1988/1989 GL1500 IMPROVED WINDSHIELD SEAL

(This supersedes GL1500 #5, dated November 1989)

MTB 4912-4938 (8911)

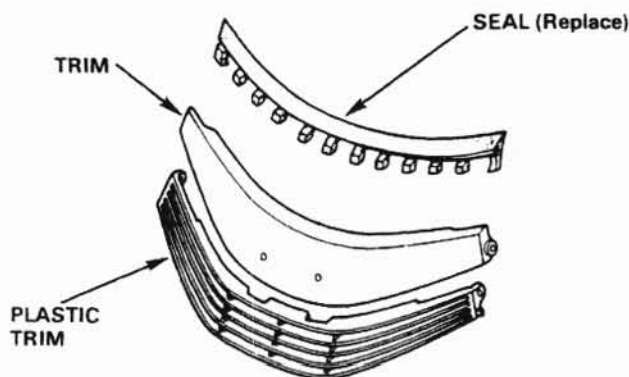
An improved windshield seal for 1988 and 1989 GL1500s is now available. This thicker seal is used on the 1990 GL and helps retain the shield in its fixed position.

In addition to the new seal, properly adjusting the windshield lever anchor screws will prevent a loose or slipping shield.

1. Remove the mirrors.
2. Remove the black plastic vent trim.
3. Remove the two screws securing the windshield trim. Free the tabs from the fairing slots and remove the trim.
4. Remove the existing seal from the back of the trim. Clean the windshield and seal mating surfaces with warm soap and water — dry completely.

5. Peel off the tape backing on the new seal. Press the seal into position on the trim.

6. Slide the trim tabs into the fairing slots and secure the trim with the two screws.
7. Adjust the windshield lever anchor screws according to service manual page 13-4.
8. Install the plastic vent trim and the mirrors.
